**Oakland City Planning Commission  
Design Review Committee**

**STAFF REPORT**

Case File Number: PLN17428 / PUDF07

# THE HUB

SHEET NUMBER **G0.7**

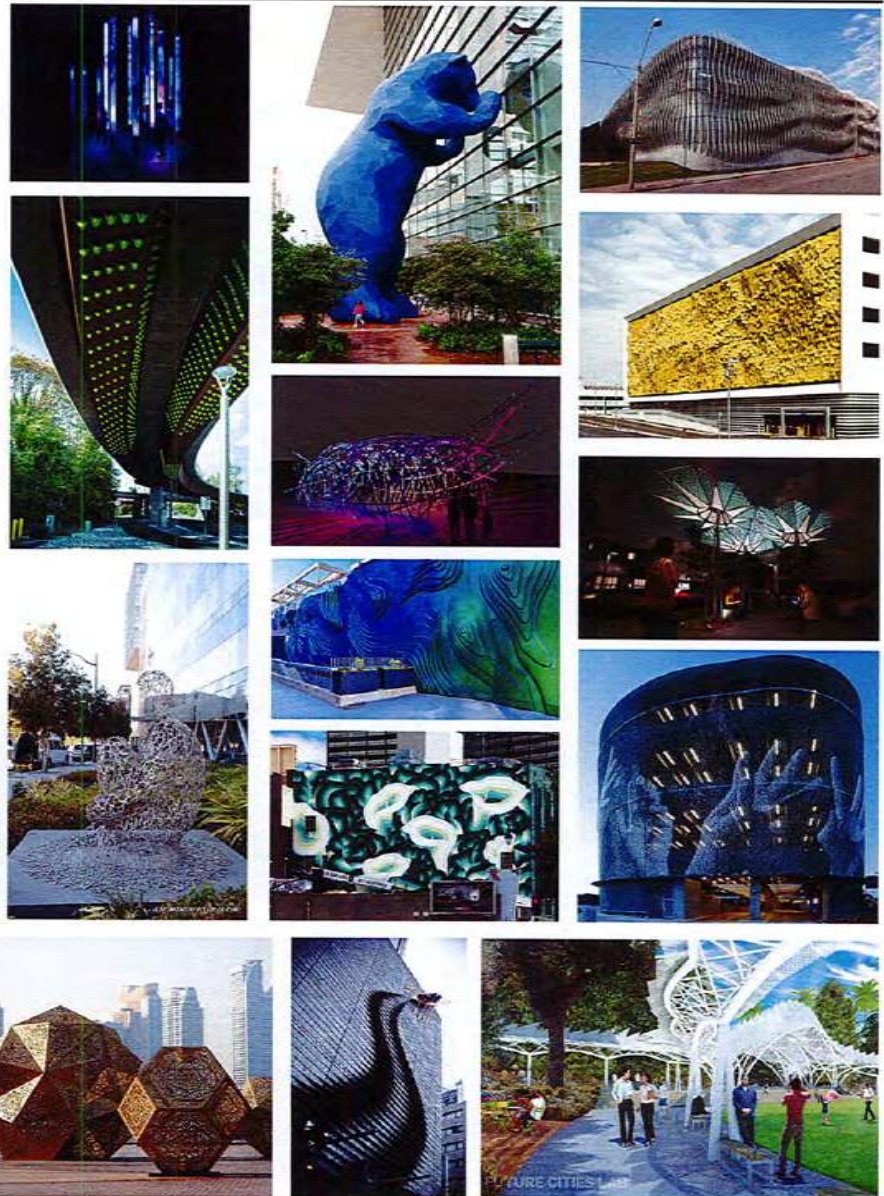
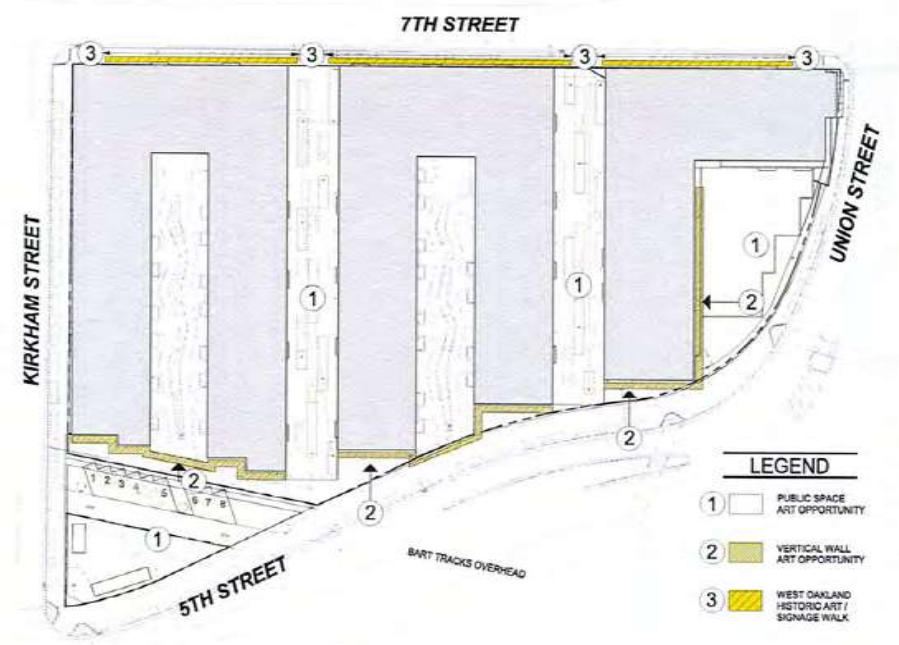
The project includes design concepts for public art within the "community gathering" pedestrian pathways and along the south and east facade of the buildings. The proposed public art range from images and other creative elements or structures. The applicant also proposes additions and/or modifications to the West Oakland Historic Art signage walk along 7<sup>th</sup> Street. These existing art works derive from the City's 7<sup>th</sup> Street Concept and Urban Design Plan by Walter Hood adopted in 2004. The intent of the Plan is to provide recommendations to reduce impacts of transportation, primarily on the 7<sup>th</sup> Street between Wood and Union Streets. The plan also recommends amenities conducive to future transit oriented development and activity with emphasis on creating a strong civic character for identity. See pages G0.7 & G0.7.1 of the design plans for details.
